**RESPONSES TO CEC COMMENTS ON THE  
MODELING PROTOCOL SUPPLEMENT FOR  
THE HYDROGEN ENERGY CALIFORNIA  
(HECA) PROJECT**

**Revised Application for Certification (08-AFC-8)**

Hydrogen Energy California (08-AFC-8)

Responses to CEC Comments on February 21, 2012 Modeling Protocol Supplement

**ATTACHMENT 4-1**

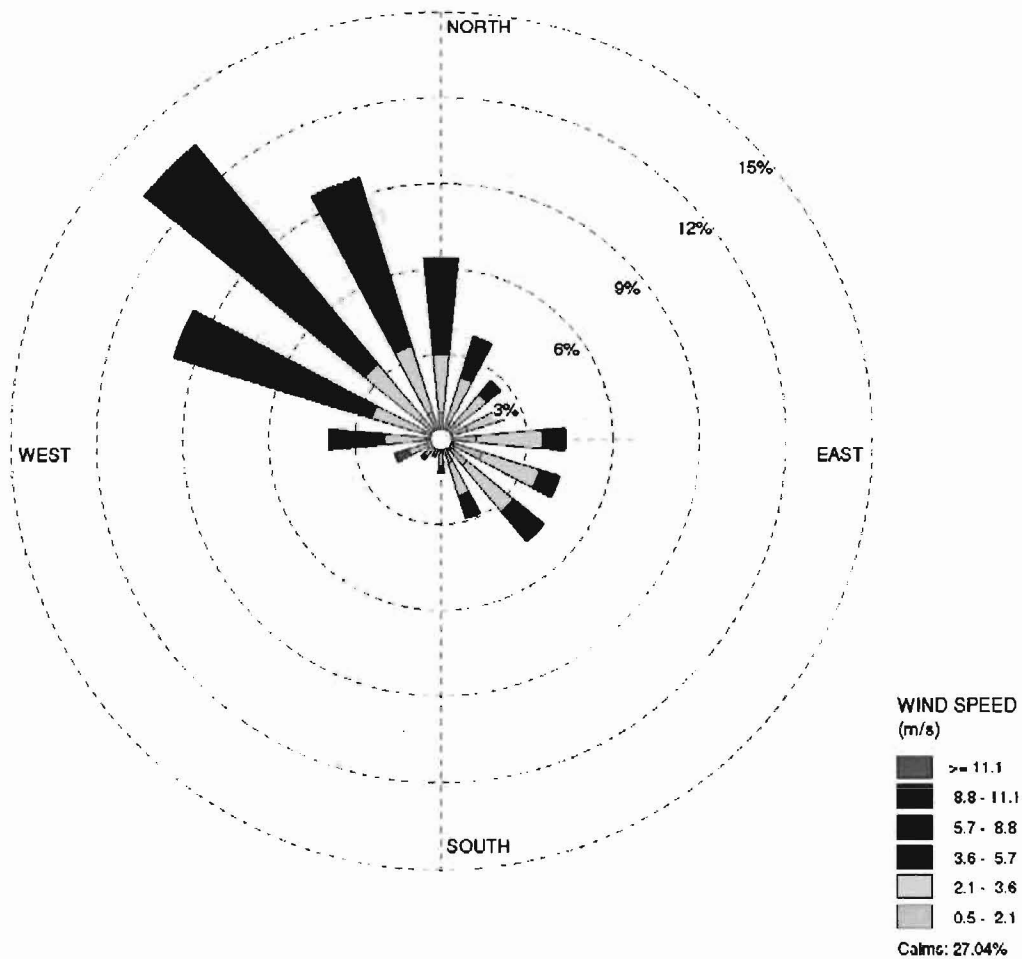
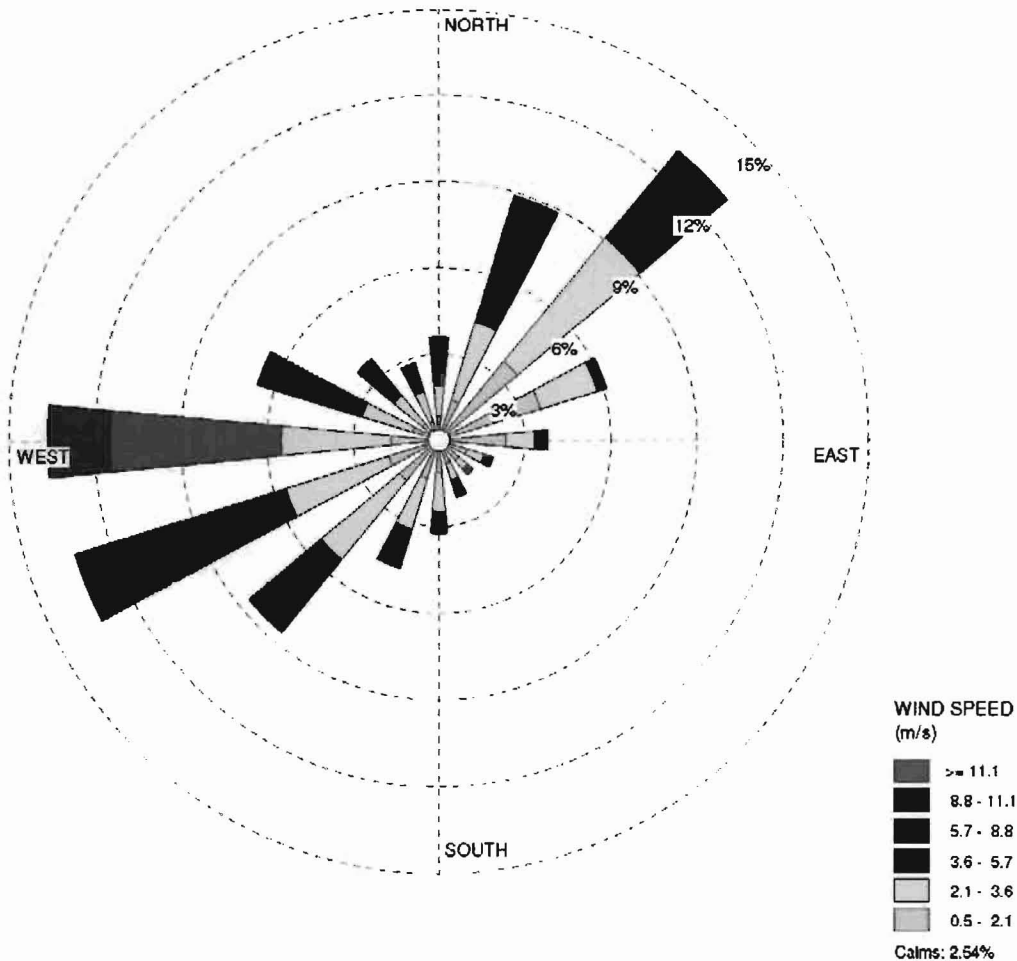
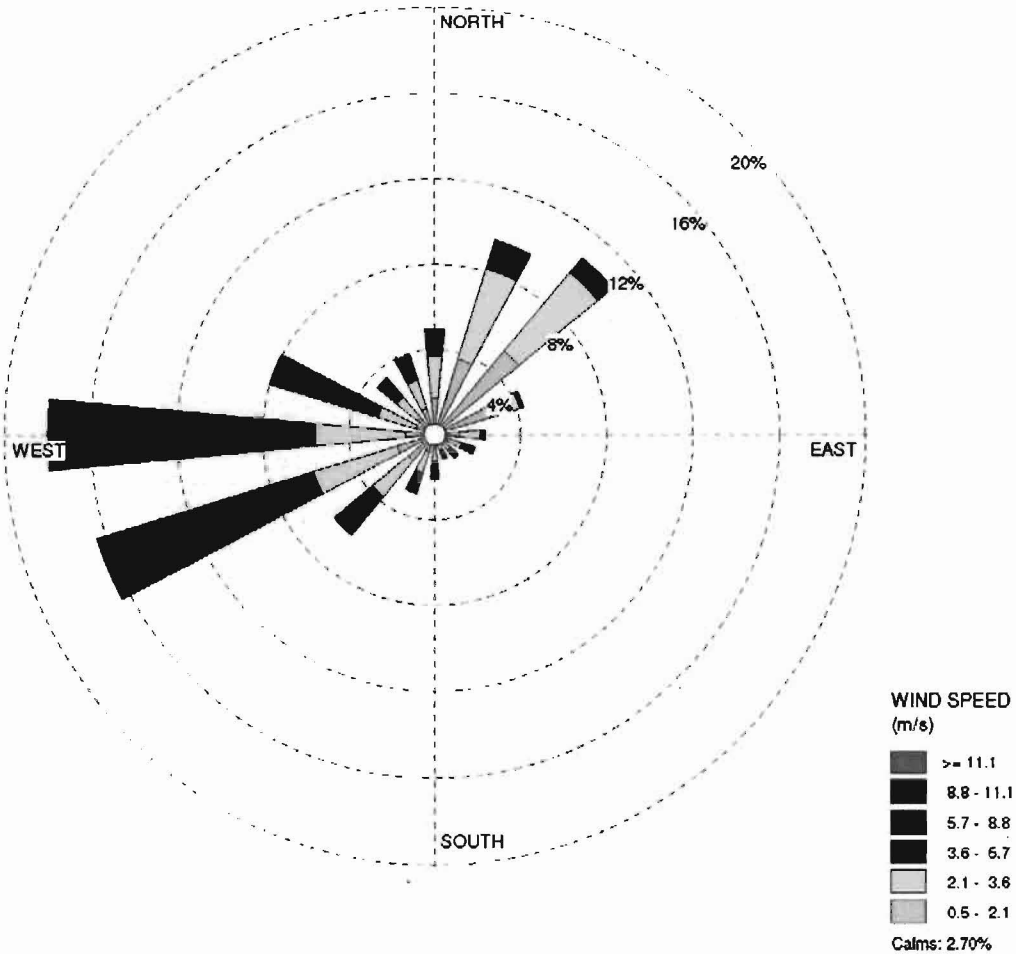
4. ***Page 9 – Meteorological data selection. It is understood given SJVAPCD modeling guidance why the Bakersfield meteorological data was selected for the criteria pollutant modeling analysis, but there is MM5 derived meteorological data from the west side of air basin that could be used for the HRA modeling. Please discuss why this data isn't being used and identify if SJVAPCD was consulted about the use of this data for the HRA and the results of that consultation.***

SJVAPCD was consulted, and they provided meteorological data to be used for all dispersion modeling analyses using the American Meteorological Society/Environmental Protection Agency Regulatory Model (AERMOD), including both Ambient Air Quality Standards and Health Risk Assessment (HRA) modeling. SJVAPCD processed and provided to HECA the data from the most representative meteorological station, the Bakersfield airport, for the five most recent available meteorological years. HRA modeling will use AERMOD and Hotspots Analysis and Reporting Program (HARP) On-Ramp with the same meteorological data set used for the criteria pollutant modeling analyses for consistency with the analyses that will be conducted by SJVAPCD in review of the air permit. SJVAPCD has provided hourly meteorological data that pair in time with the hourly background ozone and nitrogen dioxide data for 2006–2010. This is the most recent 5-year data set available for all parameters needed. HECA will be using these years of data for all modeling analyses.

To determine the most representative meteorological station, SJVAPCD and HECA considered many factors. The HECA Project is situated in a valley at a base elevation of 87 meters. The Bakersfield airport station is 20 miles away and is also situated in the valley, with an elevation of 149 meters. However, sites on the west side of the air basin that use the MM5 data for the basis of the data set are at Missouri Triangle and Fellows, both upslope in the hills west of the HECA Project Site, at base elevations of 268 meters and 472 meters, respectively. Temperatures would generally be cooler in the hills, and wind patterns are not as representative at these stations as at the Bakersfield airport station, which is situated in the valley, as is the HECA Project Site.

Attachment 4-1 presents wind roses for a comparison of wind speed and direction at Bakersfield Meadows Field Airport, Fellows, and Missouri Triangle stations for the most recent 5-year periods at each site. The wind directional patterns differ more in the valley than in the hills; therefore, the most representative meteorological data from the Bakersfield station will be used for the criteria pollutant and HRA modeling.
